## LP Hose/Connector Re-Location

It has been decided that certain 2021 Mallard M26 and 2021 Mallard M33 in this recall population may have been manufactured with the LP hose/connector over the shackle. The Shackle could come in contact with the LP hose/connector damaging them producing an LP leak.

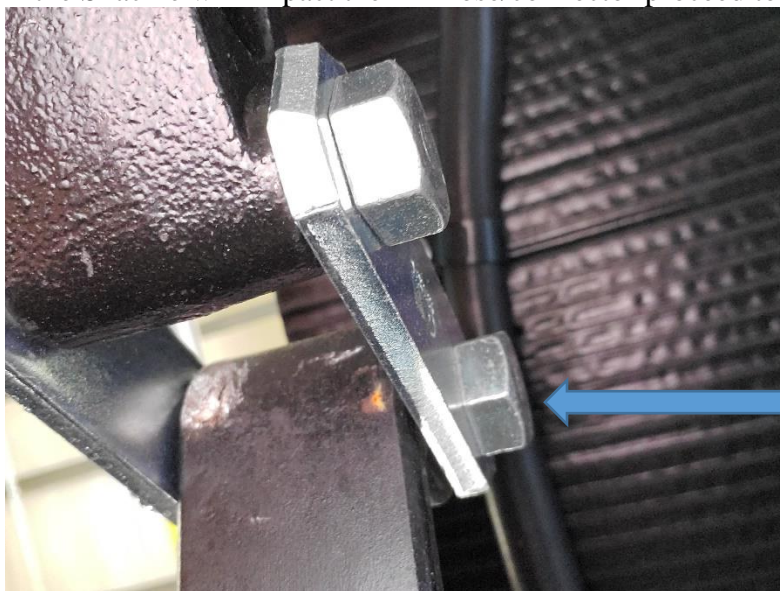
1. Shackle location in proximity to LP hose/connector. – No repair required if the shackle or shackle bolt will not impact the hose or connector. File claim for inspection only.

Notice position of shackle to the LP Hose/Connections. LP components are set back on I-beam out of shackle travel area.
